SERVICE BULLETIN

ENGINE FUEL AND CONTROL — FUEL TEMPERATURE THERMOCOUPLE —
REPLACEMENT OF, TO IMPROVE RELIABILITY

V2500 Series 73-0242

V2500-ENG-73-0242

LOCATION OF THE FUEL TEMPERATURE THERMOCOUPLE
73-35-15
FIGURE 1

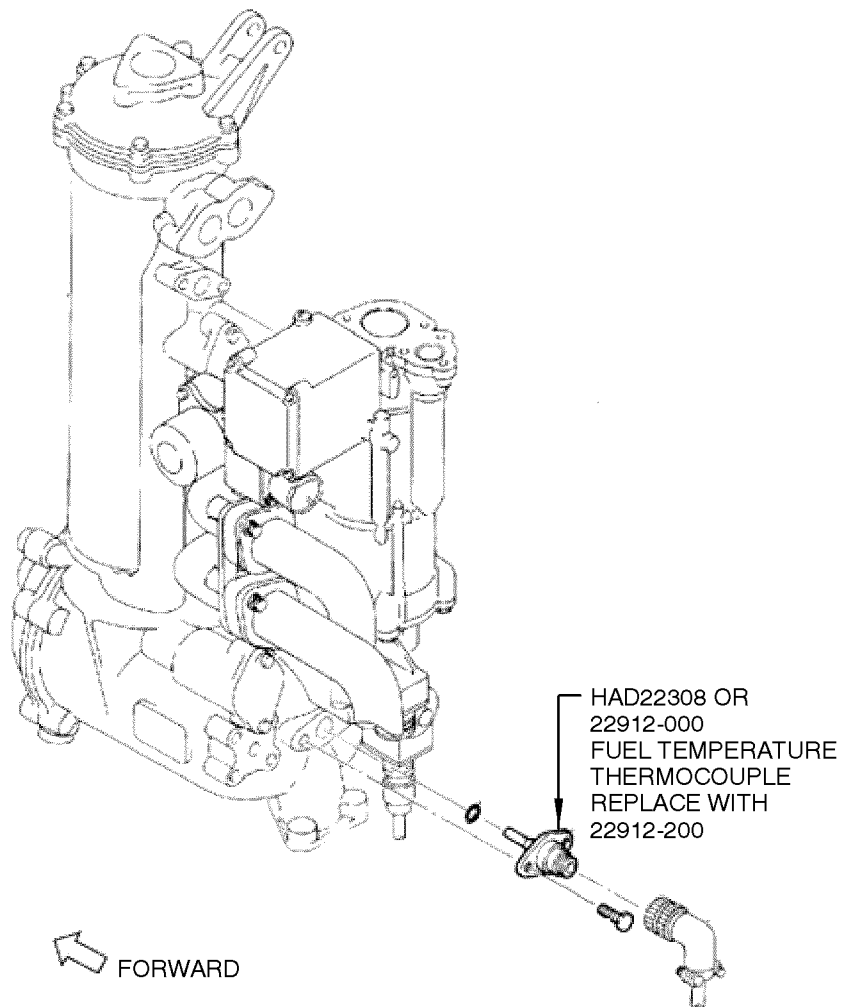
1. Replace the Fuel Temperature Thermocouple, PN HAD22308 or PN 22912-000 by the procedure that follows. See Figure 1.
 - A. Open the fan cowl doors as specified in Reference 4, Aircraft Maintenance Manual, Chapter/Section 71-13-00.
 - B. Remove the Fuel Temperature Thermocouple, PN HAD22308 or PN 22912-000 as specified in Reference 4, Aircraft Maintenance Manual, Chapter/Section 73-35-15.
 - C. Replace the Fuel Temperature Thermocouple, PN HAD22308 with PN 22912-200 or PN 22912-000 with PN 22912-200.
 - D. Install the new Fuel Temperature Thermocouple, PN 22912-200 as specified in Reference 4, Aircraft Maintenance Manual, Chapter/Section 73-35-15.
 - E. Close the fan cowl doors as specified in Reference 4, Aircraft Maintenance Manual, Chapter/Section 71-13-00.
2. Recording Instructions
 - A. A record of accomplishment is required.

1. Replace the Fuel Temperature Thermocouple, PN HAD22308 with PN 22912-200 or PN 22912-000 with PN 22912-200. See Figure 1.
2. Recording Instructions
 - A. A record of accomplishment is required.

LOCATION OF THE FUEL TEMPERATURE THERMOCOUPLE
73-35-15
FIGURE 2

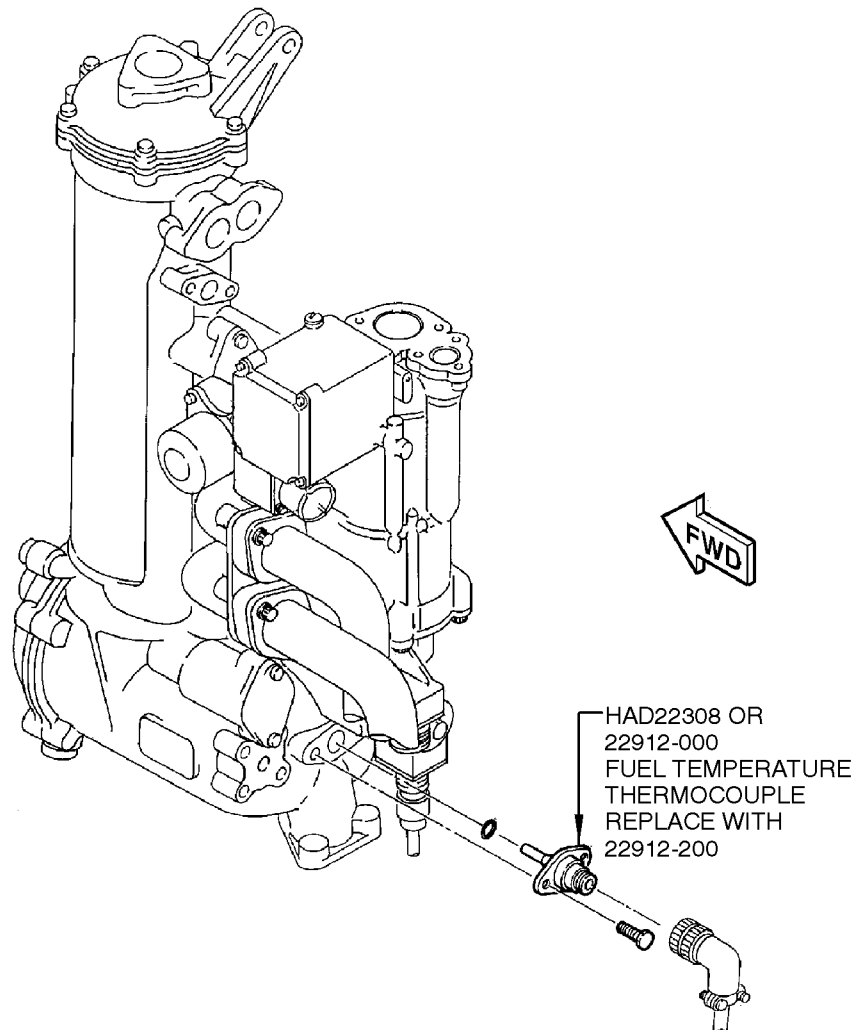
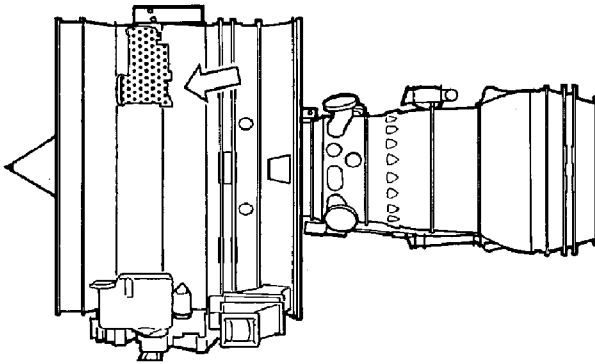
1. Replace the Fuel Temperature Thermocouple, PN HAD22308 or PN 22912-000 by the procedure that follows. See Figure 2.
 - A. Open the fan cowl doors as specified in Reference 4, Aircraft Maintenance Manual, Chapter/Section 71-13-00.
 - B. Remove the Fuel Temperature Thermocouple, PN HAD22308 or PN 22912-000 as specified in Reference 4, Aircraft Maintenance Manual, Chapter/Section 73-35-15.
 - C. Replace the Fuel Temperature Thermocouple, PN HAD22308 with PN 22912-200 or PN 22912-000 with PN 22912-200.
 - D. Install the new Fuel Temperature Thermocouple, PN 22912-200 as specified in Reference 4, Aircraft Maintenance Manual, Chapter/Section 73-35-15.
 - E. Close the fan cowl doors as specified in Reference 4, Aircraft Maintenance Manual, Chapter/Section 71-13-00.

1. Replace the Fuel Temperature Thermocouple, PN HAD22308 with PN 22912-200 or PN 22912-000 with PN 22912-200. See Figure 2.
2. Recording Instructions
 - A. A record of accomplishment is required.

FUEL TEMPERATURE THERMOCOUPLE CHART A

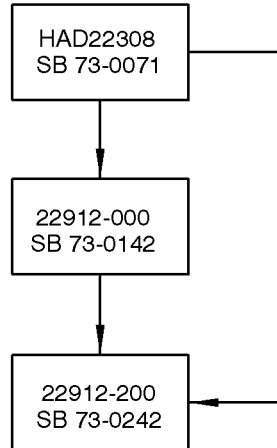
New PN	Qty	Estimate of Unit Price (\$)	Keyword	Old PN	Instructions — Disposition
22912-200	1	*	THERMCPL — FUEL TEMP	HAD22308 (73-35-15-01-100)	(2)(B)(N) (S)(V)
22912-200	1	*	THERMCPL — FUEL TEMP	22912-000 (73-35-15-01-100)	(2)(B)(N) (S)(V)
